MFN 06-455
Supplement 1

Subject: Response to Portion of NRC Request for Additional Information
Letter Number 37 Related to ESBWR Design Certification
Application – Siting Issues – RAI Number 2.3-9 S01

**Response to Portion of NRC Request for Additional
Information Letter No. 37 Related to ESBWR
Design Certification Application**

RAI Number 2.3-9 S01

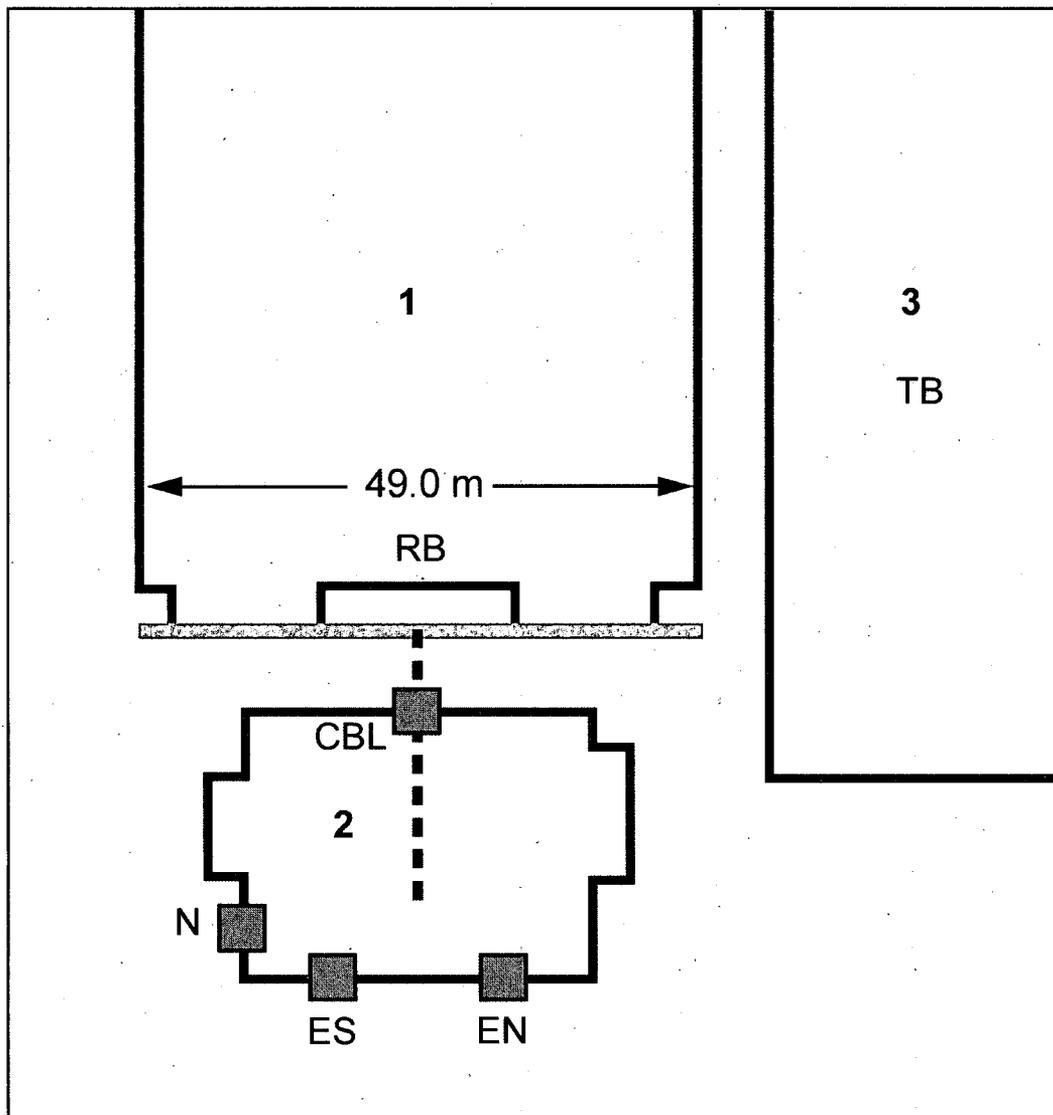
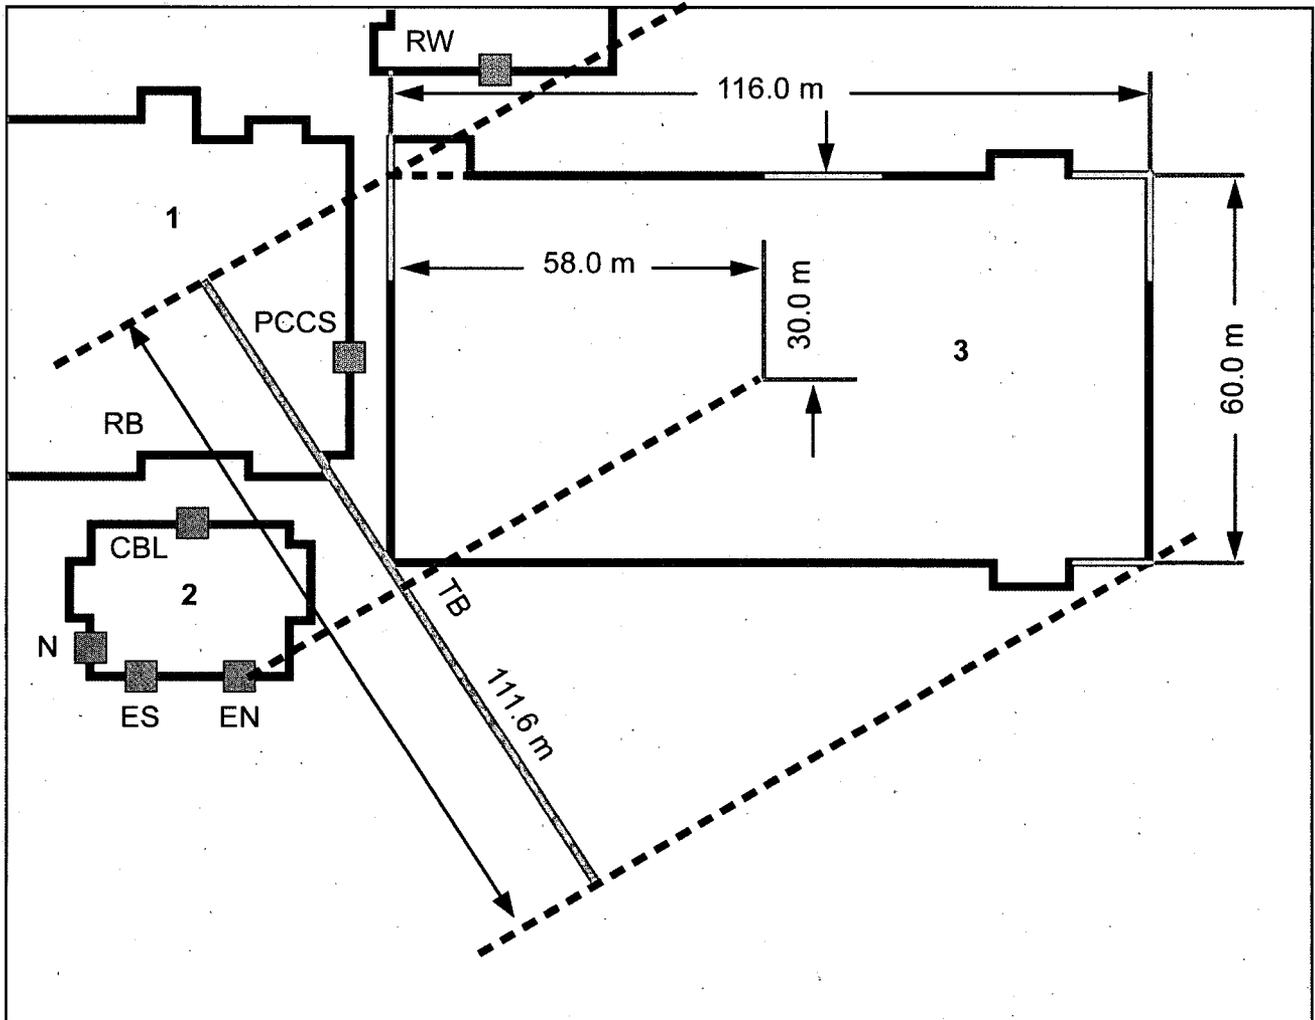
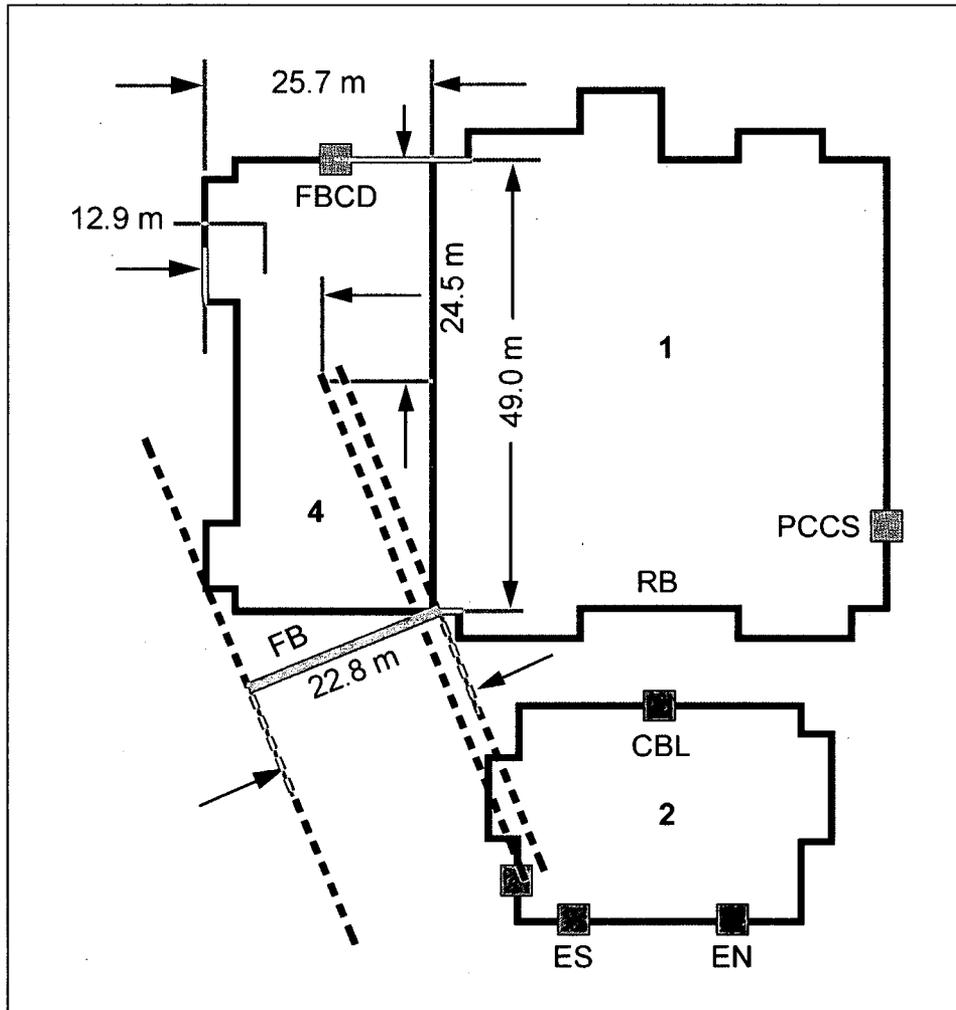
(i) Regulatory position 3.2.4.5 of Regulatory Guide 1.194 states that the height and width of the diffuse area source (e.g., the building surface) should be the maximum vertical and horizontal dimensions of the above-grade building cross-sectional area perpendicular to the line of sight from the building center to the control room intake. These dimensions should be projected onto a vertical plane perpendicular to the line of sight and located at the closest point on the building surface to the receptor. Please confirm that this is the approach used to calculate the diffuse area sources for the reactor building and turbine building leakage pathways. [[

While the previous approach to the diffuse sources was conservative, in response to this RAI the heights and widths of the diffuse sources have been refined as described in Regulatory position 3.2.4.5 of Regulatory Guide 1.194 for accuracy and consistency

with the guidance. The refined values for the diffuse source widths, areas, and initial diffusion coefficients will not change bounding ESBWR X/Q values, however, they will be listed in the associated ARCON96 inputs for use by future COL applicants for verification of the ESBWR X/Q values that are to be provided in DCD Revision 5 Appendix 2A. Diffuse source areas are established based on dominant intake location. The diffuse sources modeled for DCD dose analyses for the Control Room are depicted in the figures below.

Figure 2A-1. Potential Radiological Sources and Receptors for the ESBWR Control Room
(see next page for explanation of designations used on figure)

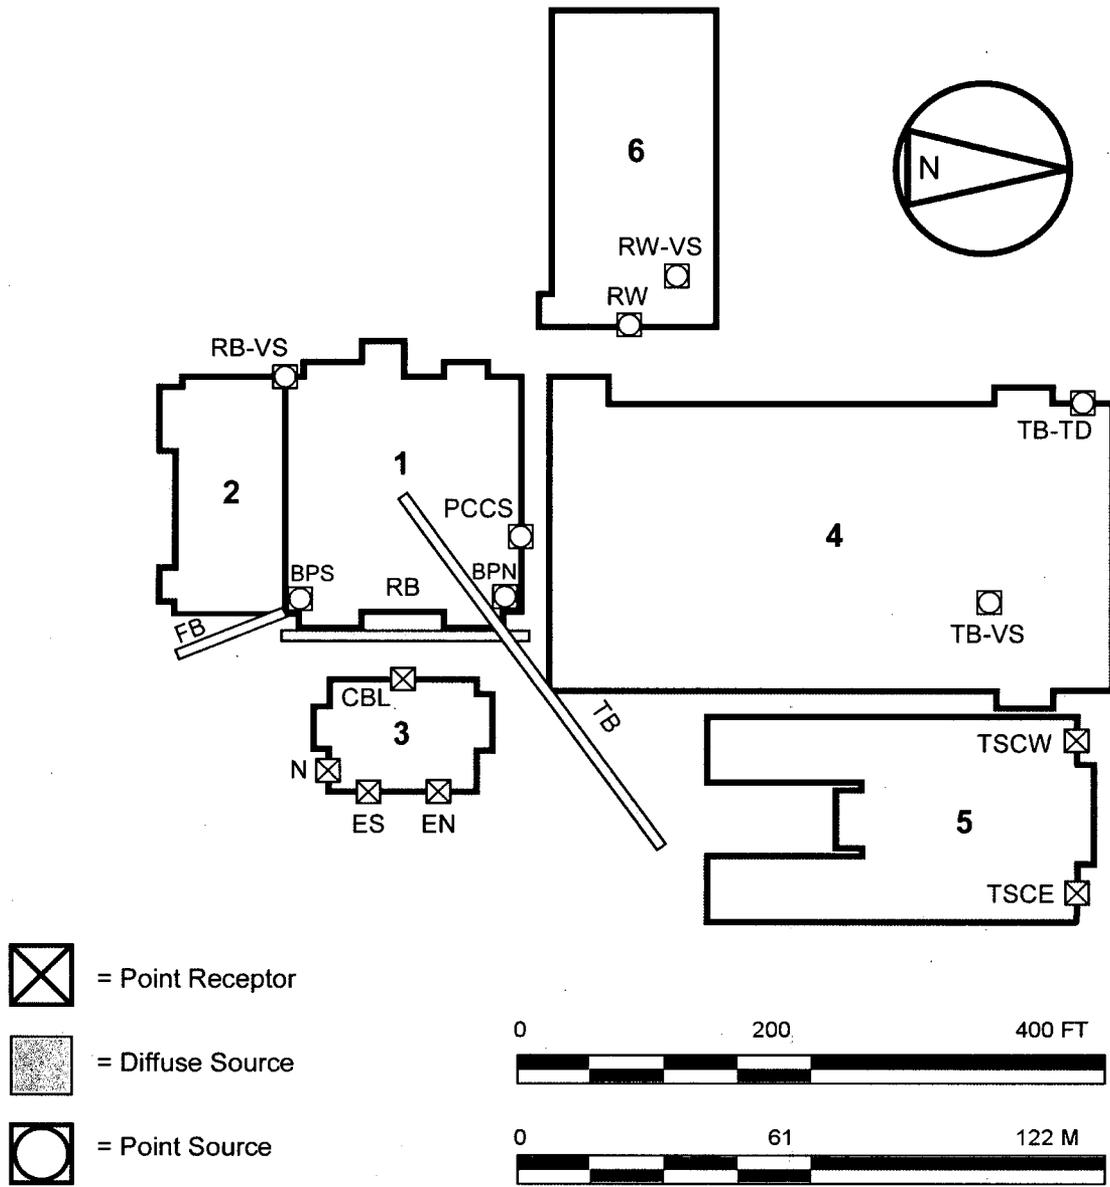
- (i) Please provide one scaled general arrangement drawing showing all potential release pathways and receptors. Plant north should be indicated on this drawing.*

A scaled drawing showing all potential release pathways and receptors for use with Control Room radiological dose evaluations indicating ESBWR Plant North based on General Arrangement Drawing in Figure 2A-1 of DCD will be provided in Revision 5 of the DCD in Appendix 2A.

During preparation of this RAI response, it was confirmed that the TB vent panels are not part of the ESBWR design. The text in DCD Subsection 15.4.4.5.2.4 was incorrectly stated. The TB truck doors have been included in Figure 2A-1 and in Table 2A-2, and the bounding TSC receptor (TSCW)/ TB truck door pair has been included in Table 2A-3.
